# Access Compliance Report

## Public Rights-of-Way

### (Curb Ramps)

Intersection ID: 48944	Main Street: LILLYSHIRE_PL	Cross Street: CALDWELL_RIDGE_PY	Location: SE
ADA ID: A2FD225663AB	Ramp Type: Perp	Initial Pass/Fail: Fail	Overall Compliance: No
Codes/Mitigation Info/Possible Solution		Field Measurements/Component Compliance	
Severity Score: 21.25

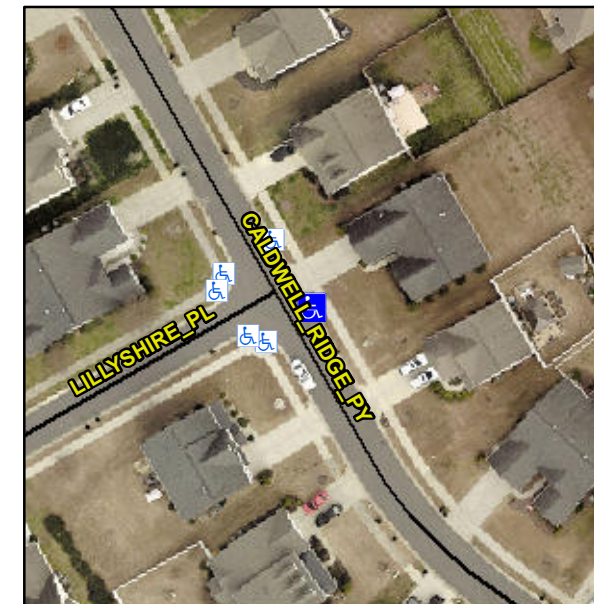
**Not Found, R304.5.1, R304.2.2**

Compliance	Description	Data	Compliance	Description	Data
N/A	Ramp Length (in)	46.5	No	Ramp Slope (%)	8.5
No	Ramp Width (in)	47.0	Yes	Ramp XSlope (%)	1.5
N/A	Flare Type LT	N/A	N/A	Flare Type RT	N/A
N/A	Flare Slope LT (%)	N/A	N/A	Flare Slope RT (%)	N/A
N/A	Flare Traversable LT?	N/A	N/A	Flare Traversable RT?	N/A
N/A	Landing Length (in)	N/A	N/A	DWS Provided?	N/A
N/A	Landing Width (in)	N/A	N/A	DWS Contrast?	N/A
N/A	Landing Slope (%)	N/A	N/A	DWS Length (in)	N/A
N/A	Landing X Slope (%)	N/A	N/A	DWS Full Width?	N/A
N/A	Landing Curb? (Y/N)	N/A	N/A	DWS Offset (in)	N/A
N/A	Shared Landing?	N/A			
N/A	Gutter Ponding?	N/A	N/A	Gutter Slope (%)	N/A
N/A	Gutter Lip Ht (in)	N/A	N/A	Gutter X Slope (%)	N/A
N/A	Painted X Walk1?	No	N/A	Painted X Walk2?	N/A
	X Walk 1 Direction	To SW		X Walk 2 Direction	N/A
N/A	X Walk 1 Width (in)	N/A	N/A	X Walk 2 Width (in)	N/A
	X Walk 1 Slope (%)	2.3		X Walk 2 Slope (%)	N/A
	X Walk 1 X Slope (%)	1.7		X Walk 2 X Slope (%)	N/A

**Remove & Replace Entire Ramp.**
